FIRE SAFETY INSPECTION REPORT

Laila Styles Ltd

ACCORD ID: 23622

Date: 27 January, 2019

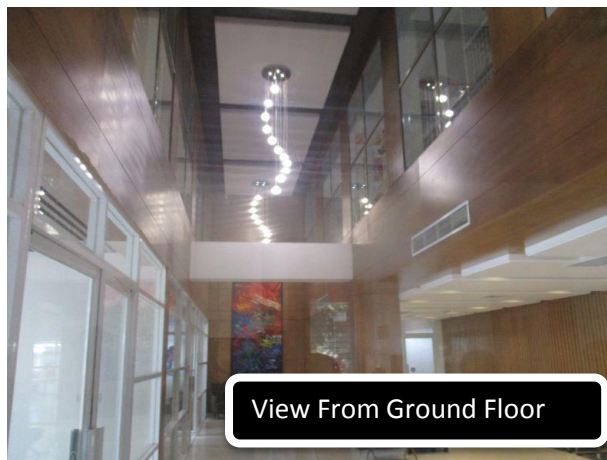
SI No.	Category	Findings	Required Action	Remediation Time Frame
1	Fire Separation	Atrium connecting 1st to 5th floor which is also used for carrying ventilation duct lines, is not properly separated by fire rated construction on each floor. Location: Building 1 : Main production building, in between stair-5 & 2.	Separate the atrium area by 2 hr. fire rated construction on each floor or provide sprinkler system as per ACCORD building standard 3.7.4. [Reference NFPA 101, 6.1.14.4.6, 8.6.7]	Within 6 months

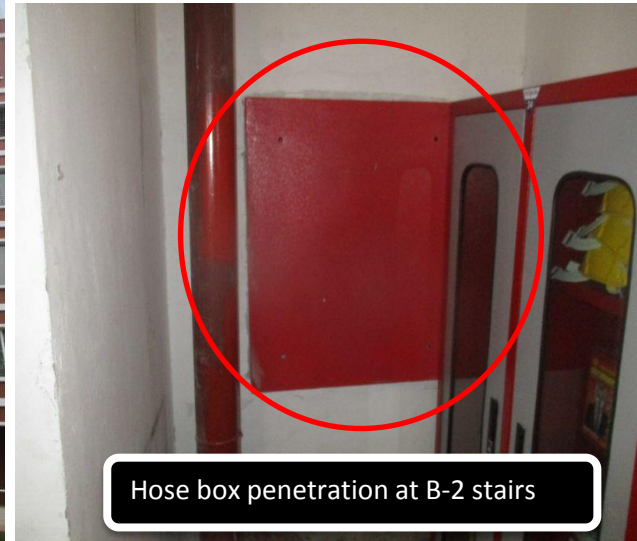
2	Fire Separation	North-East exit stair discharge the occupants inside the building. Location: Building-1, Stair-1	1. Modify stair to discharge directly outside. Or 2. Provide 2-hr fire-rated exit passageway leading directly outside (vestibules to separate any storage areas).	Within 3 months
---	-----------------	--	---	-----------------

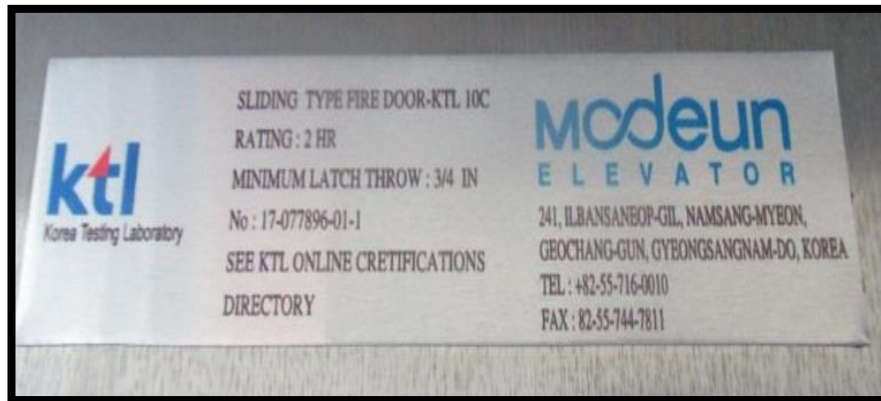
9	Directional Sign	Directional signs are not provided where direction of the path of travel to an exit has changed. Location: Building-2,	Illuminated directional signs shall be provided where there is a change in the direction for the path of travel and the direction to an exit is not obvious.	Within 1 month
---	------------------	--	--	----------------
